**STATE OF TENNESSEE
DEPARTMENT OF TRANSPORTATION**

INSTRUCTIONAL BULLETIN NO. 21-20

Regarding Various Revised, New and Voided Standard Drawings

Effective May 13, 2022 letting (March 2, 2022 Turn-in), the following Standard Drawings have been revised or are new. In addition, the Roadway Design Guidelines Chapter 7 – Item Numbers, Sections 7-611.00, Manholes, Catchbasins, Inlets and Pipe End Walls, and Section 7-705.00, Guardrails, of the Roadway Design Guidelines has been modified to reflect any changes to or new item numbers in the Standard Drawings of this Instructional Bulletin.

CORNER SIDEWALK AND CROSSWALK CLOSURES WITH OPTIONAL TEMPORARY CROSSWALK

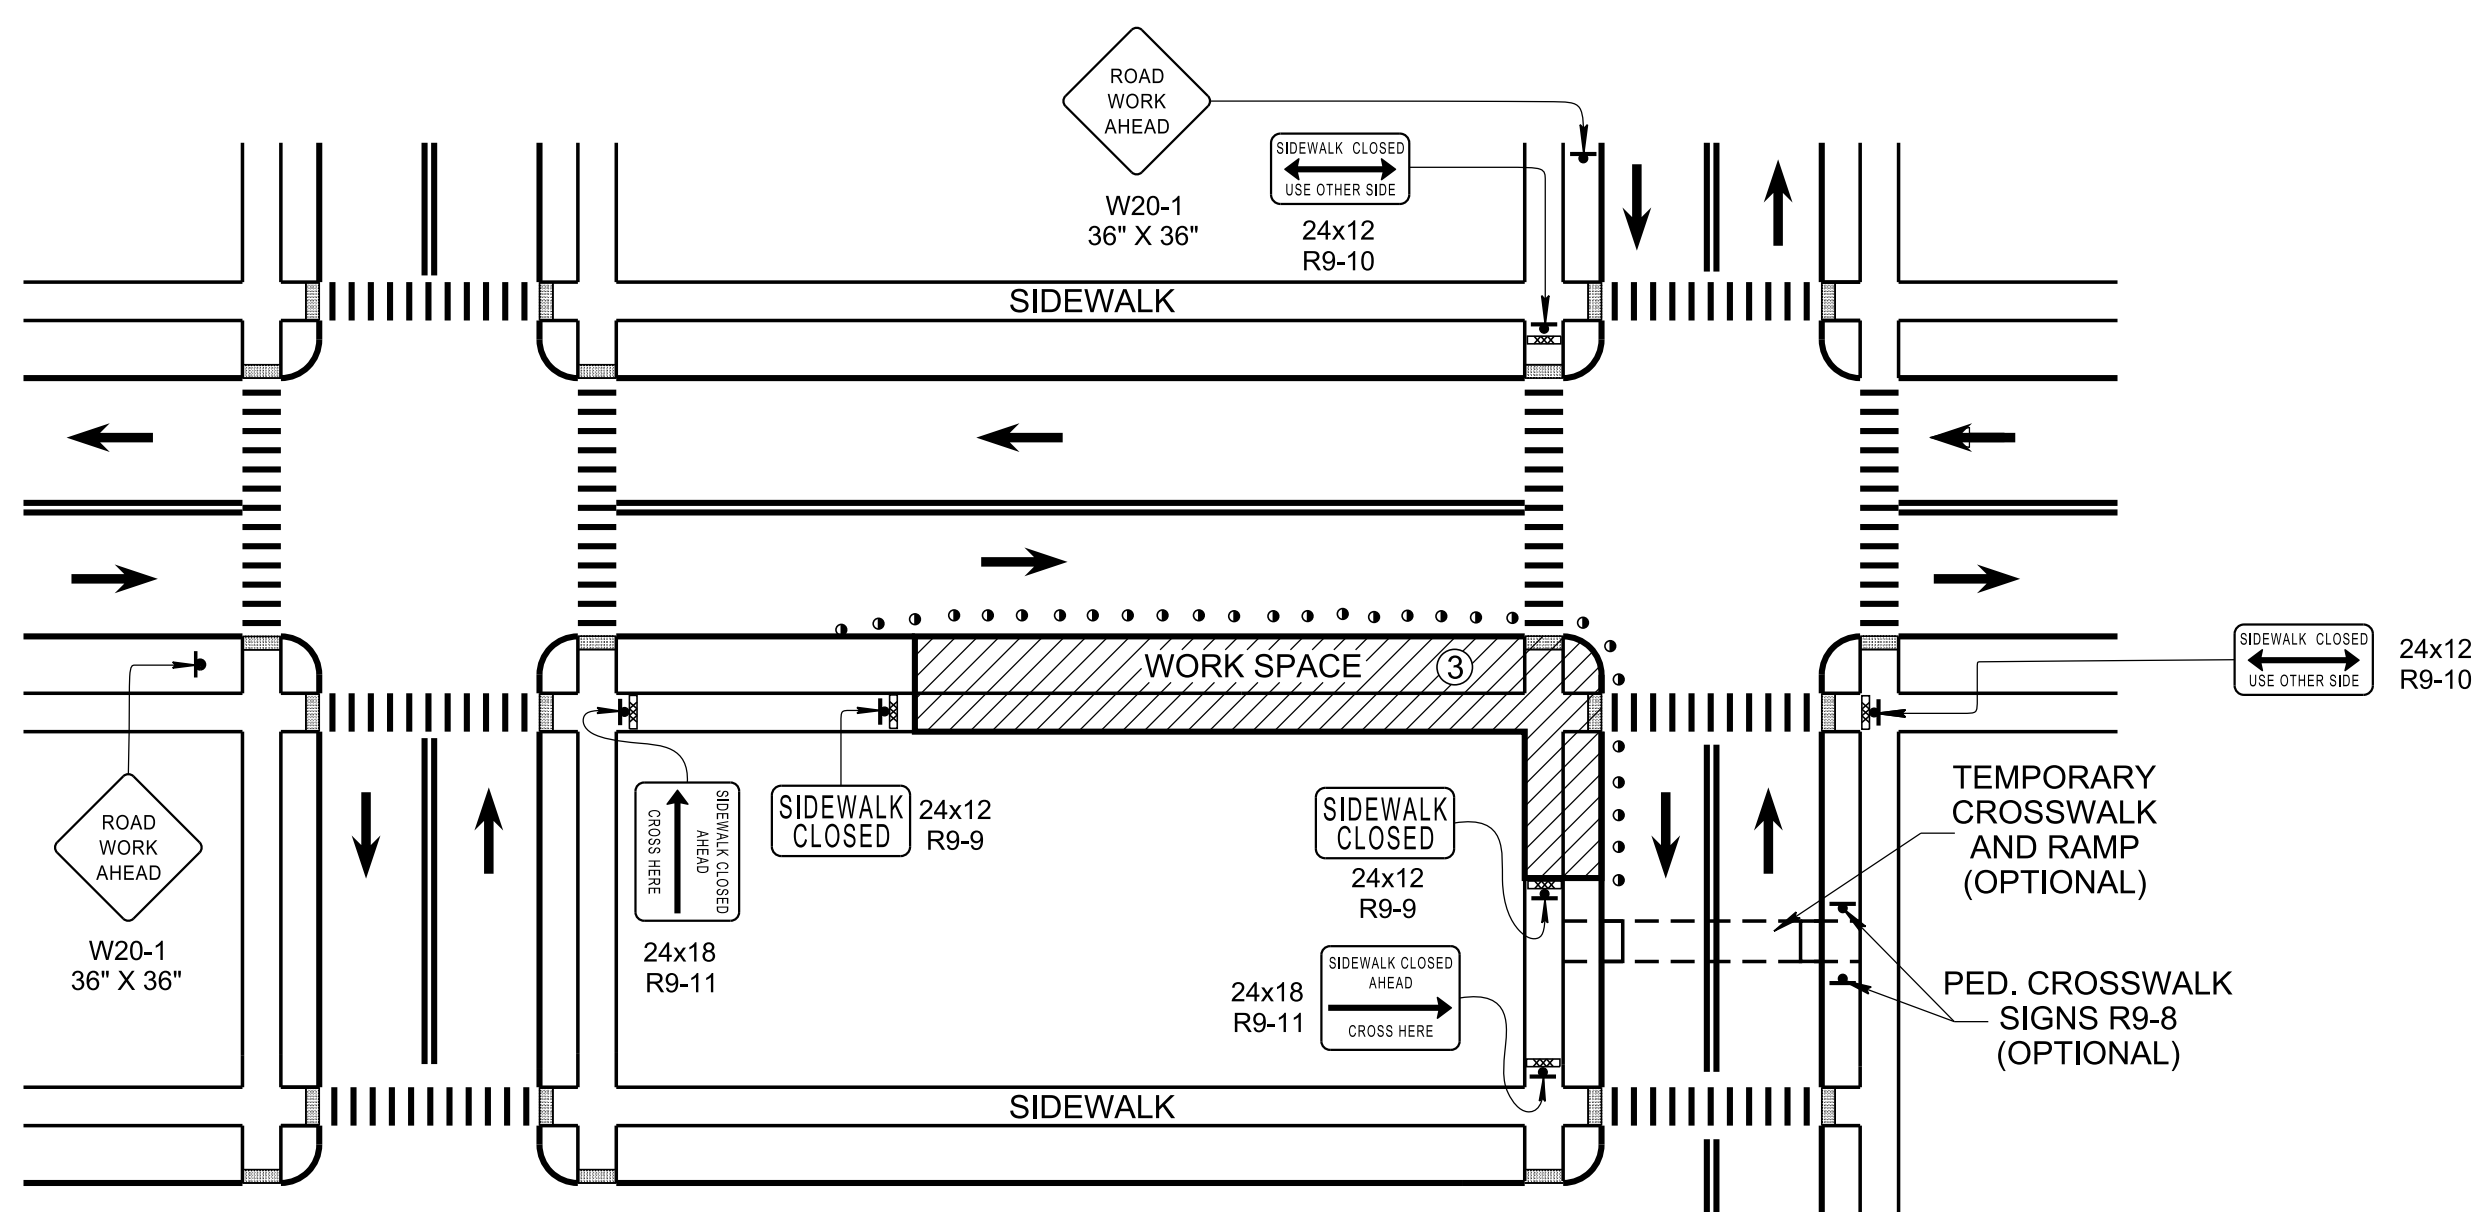
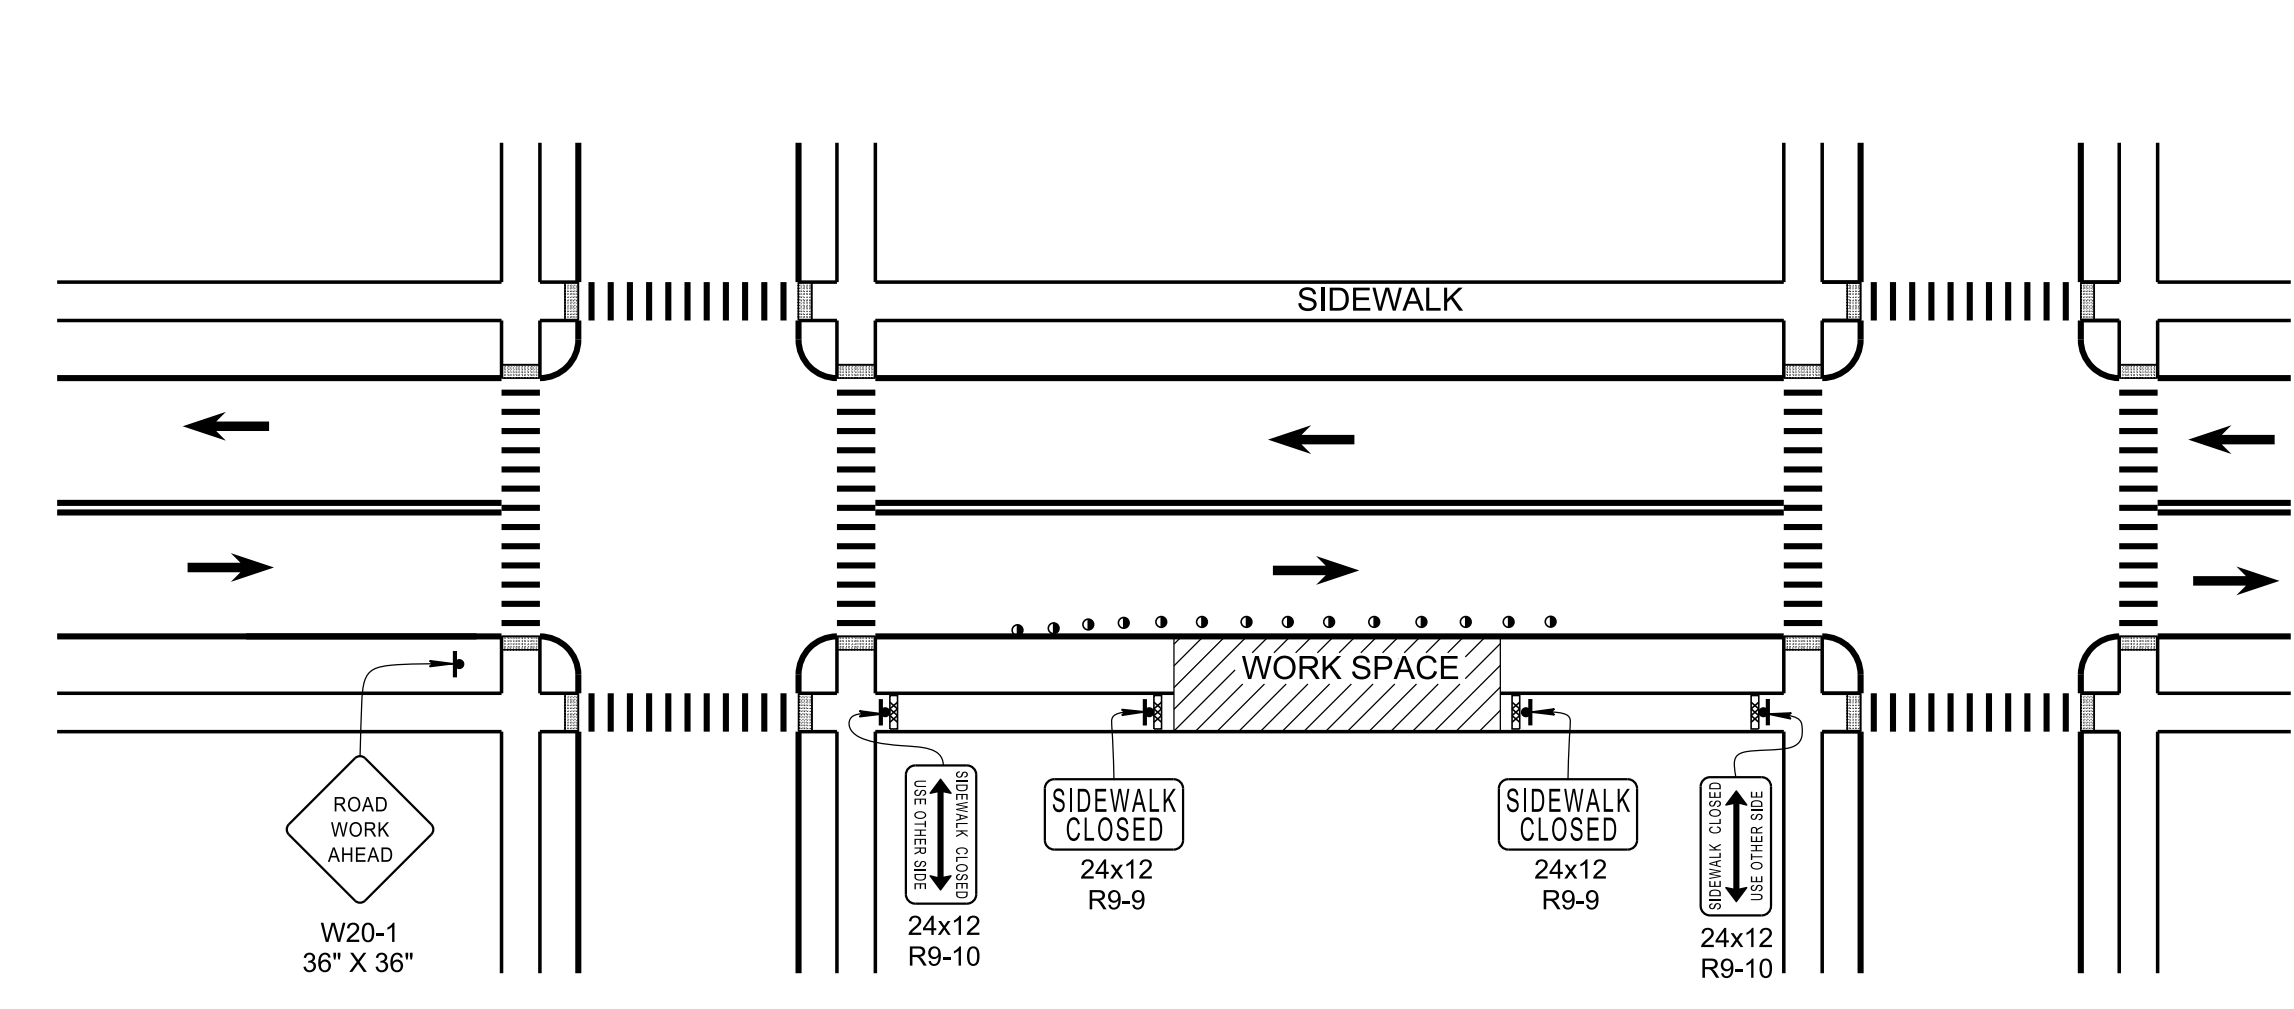
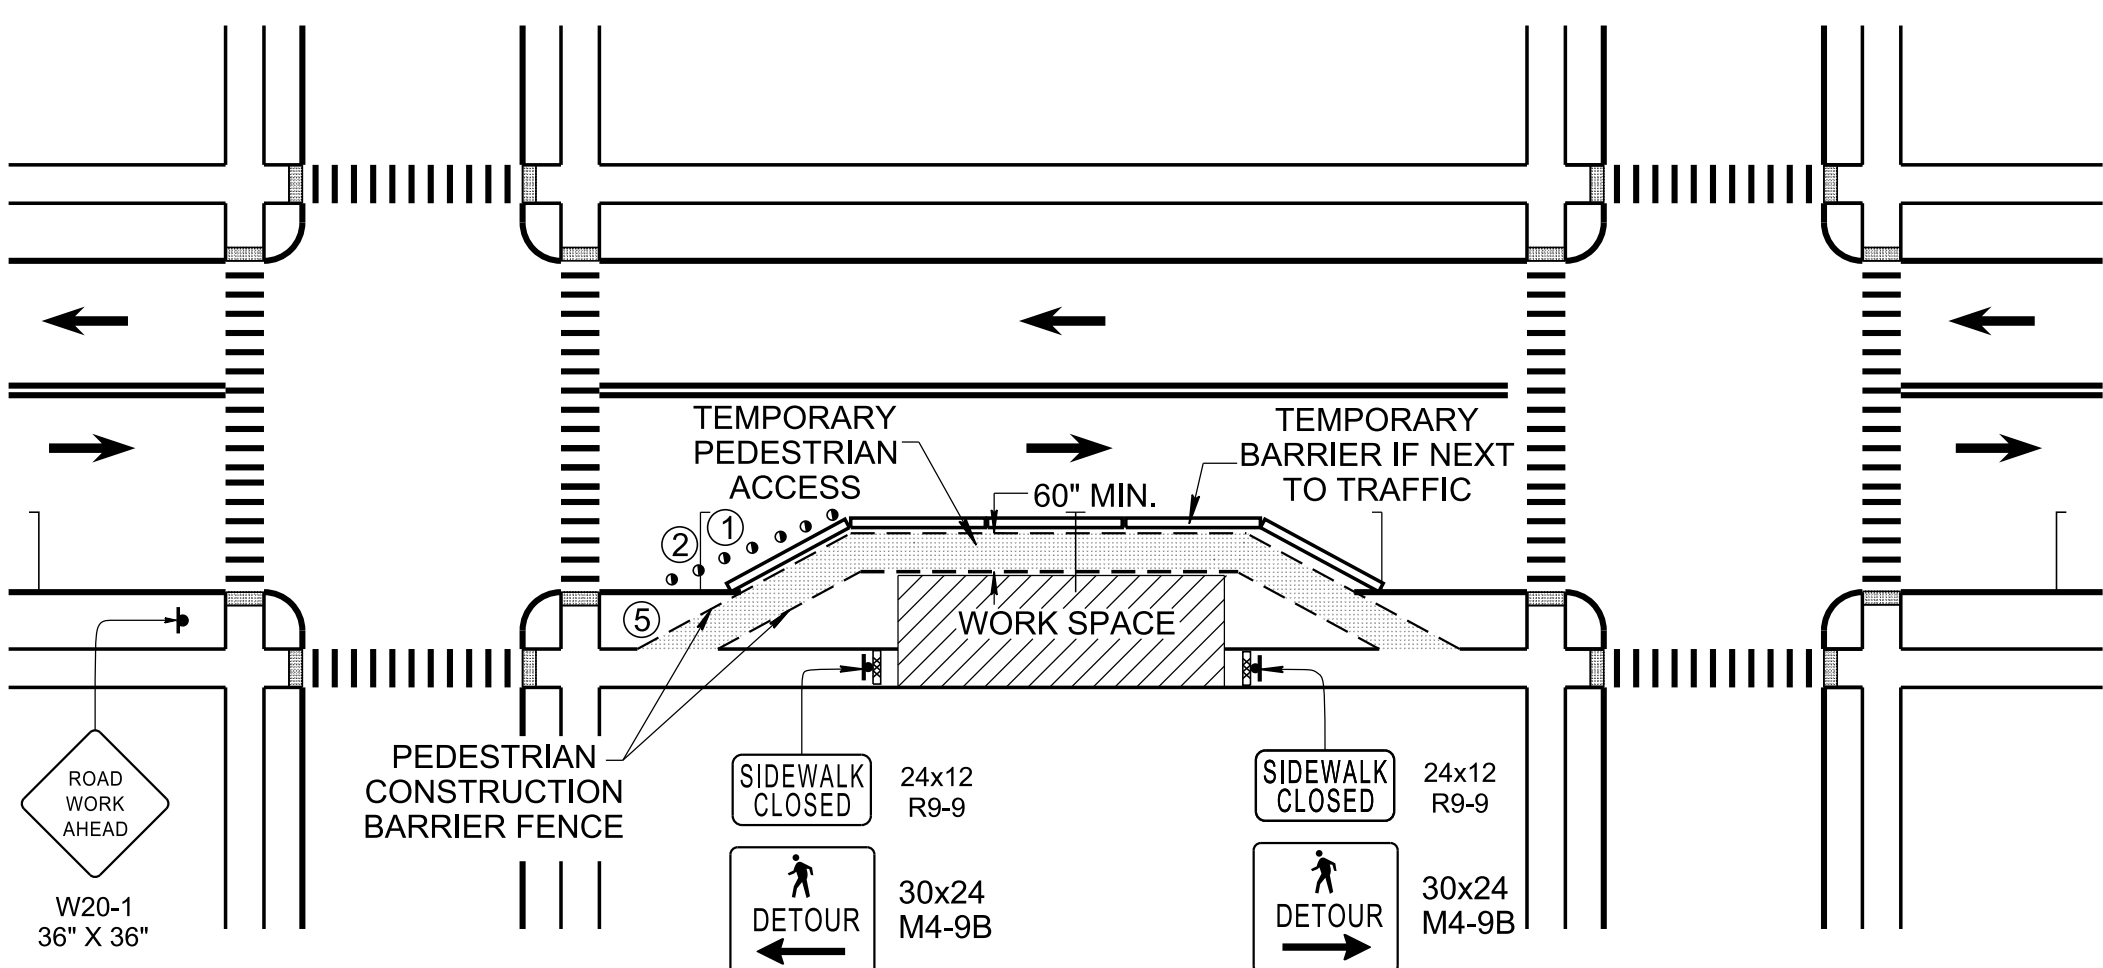
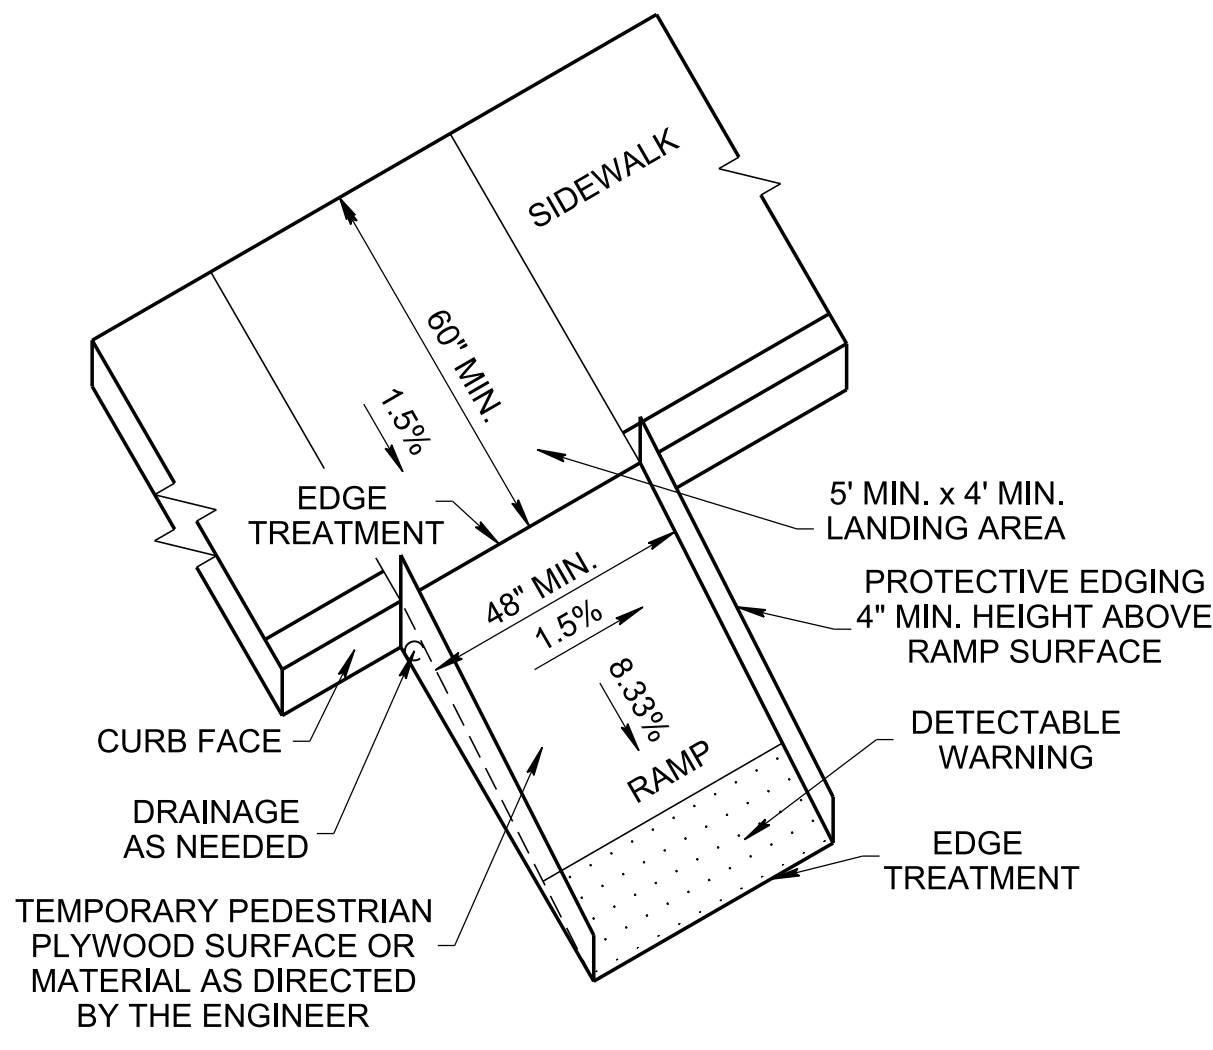
- REV. 6-30-14: ADDED ITEM NUMBER FOR PEDESTRIAN CONSTRUCTION BARRIER FENCE.
- REV. 10-10-16: UPDATED GENERAL NOTE (E) FOR SIDEWALK DIVERSION.
- REV. 10-29-2021: SIDEWALK DIVERSION, SIDEWALK CLOSURE MIDBLOCK AND CORNER DRAWINGS WERE REDRAWN. PLYWOOD CURB RAMP DETAIL WAS REMOVED. TEMPORARY PEDESTRIAN ACCESS ROUTES PERPENDICULAR AND PARALLEL CURB RAMP OPTIONS WERE ADDED. CHANNELIZATION DEVICE LEGEND WAS REVISED. FOOTNOTES (1) WAS REVISED. GENERAL NOTES FOR SIDEWALK DIVERSION (E) AND SIDEWALK CLOSURE (A) WERE REVISED.
